Sandy Plains Senior Living

Sheet:
CSP 7

PETITION NO: Z-106

PROPOSED USE: Assisted Living Facility

Project No:
 Conceptual Site Plan Scheme G

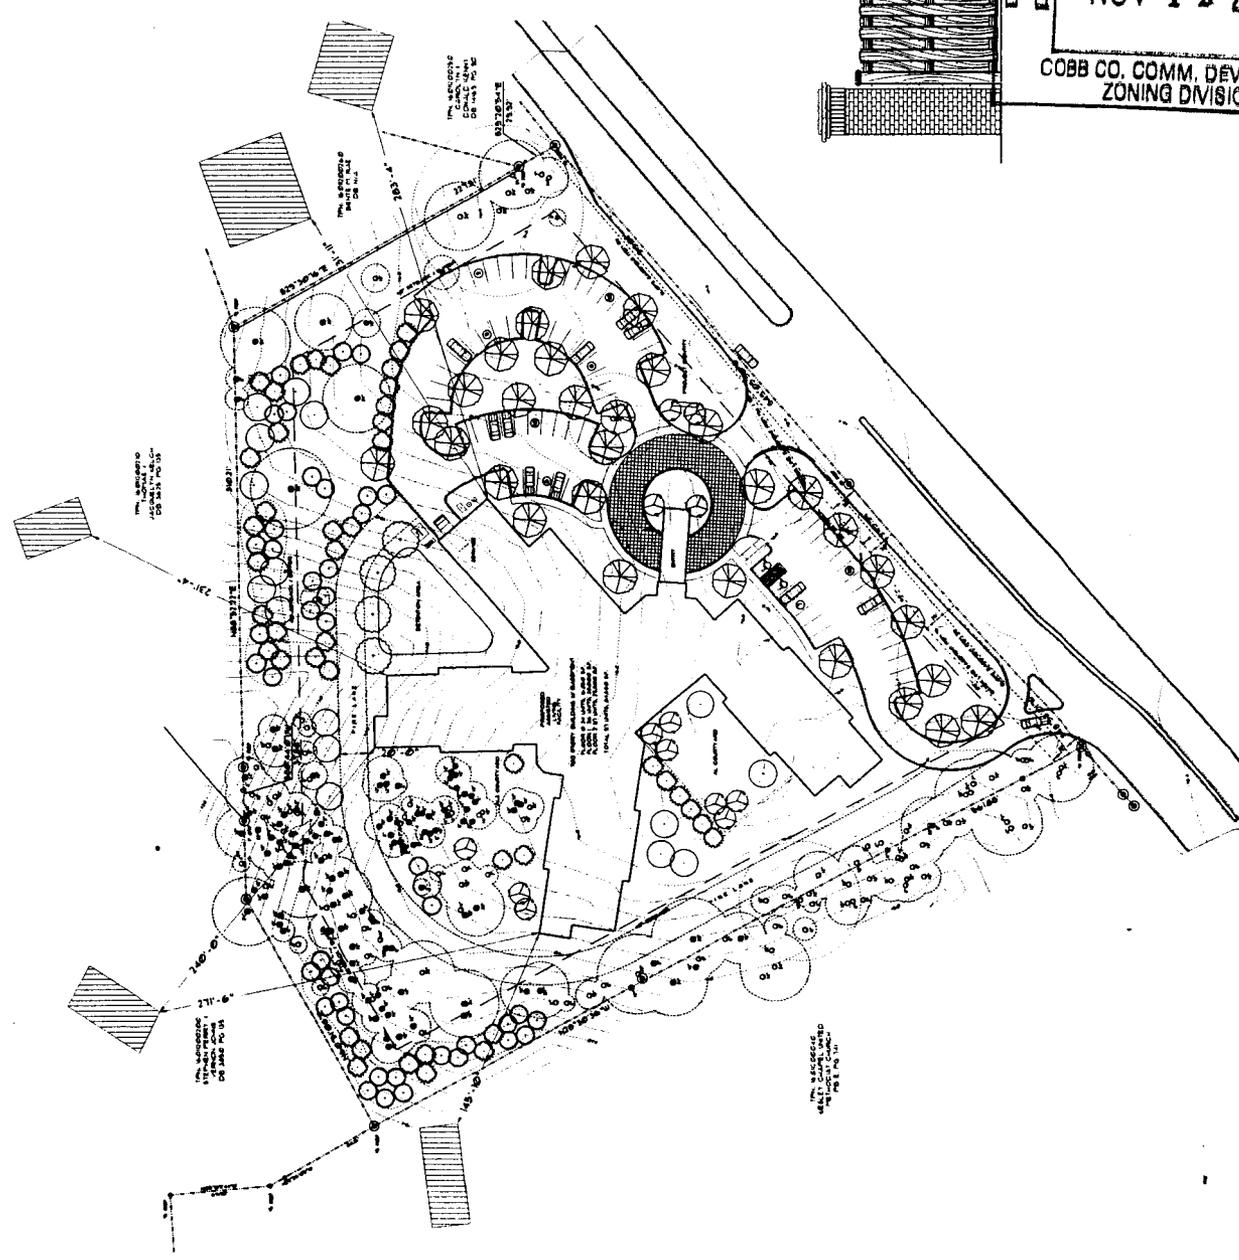
- Provide comprehensive hydrology/stormwater controls to include development of out parcels.
- Submit all proposed site improvements to Plan Review.
- Any **spring activity** uncovered must be addressed by a qualified geotechnical engineer (PE).
- Structural fill _____ must be placed under the direction of a qualified registered Georgia geotechnical engineer (PE).
- Existing facility.
- Project must comply with the Water Quality requirements of the CWA-NPDES-NPS Permit and County Water Quality Ordinance.
- Water Quality/Quantity contributions of the existing lake/pond on site must be continued as baseline conditions into proposed project.
- Calculate and provide % impervious of project site.
- Revisit design; reduce pavement area to reduce runoff and pollution.

- No Stormwater controls shown _____
- Copy of survey is not current - Additional comments may be forthcoming when current site conditions are exposed.
- No site improvements showing on exhibit.

4. The proposed detention pond discharge is a fairly well defined conveyance. However, the subdivision plat for Jefferson Township Phase 10 does not show a recorded drainage easement for this flow path. This issue must be resolved in Plan Review
